Re: Oyster Creek Nuclear Generating Station
Docket No. 50-219
SEP Structural Topics

ATTACHMENT A
OYSTER CREEK NUCLEAR GENERATING STATION
SEP STRUCTURAL TOPICS

OYSTER CREEK NUCLEAR GENERATING STATION
Additional Information
Structural Topics

FIGURE C-2

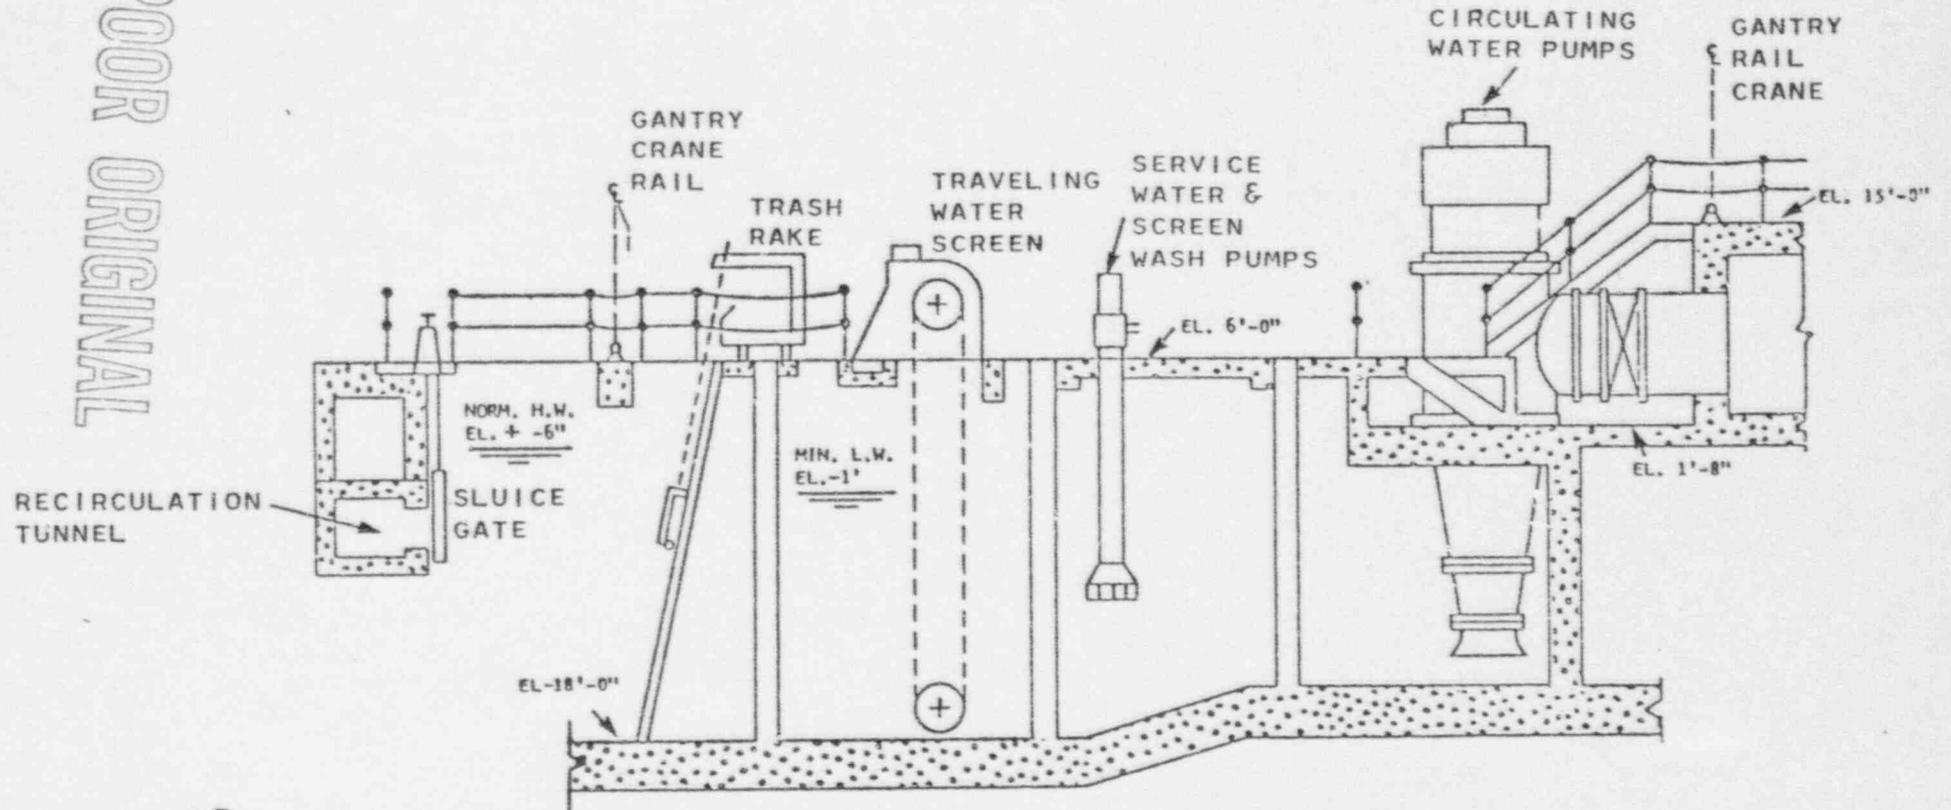
9c. Either show that all plant features outside of the barrier provided by the reactor-turbine building complex are not necessary for cooldown, or that all features outside the reactor-turbine building complex can withstand very severe wave action, or provide a detailed wave analysis that will demonstrate that during a postulated PMH wave action on these exterior facilities will not impair their functionality.

The locations of these plant features are shown in Figure C-1. The circulating water and service water pumps are mounted on a deck at Elevation +6 feet MSL above the intake structure. An elevation section of the intake structure is shown in Figure C-2. The standby diesels are located on the plant grade at Elevation +23 feet MSL alongside the discharge canal.
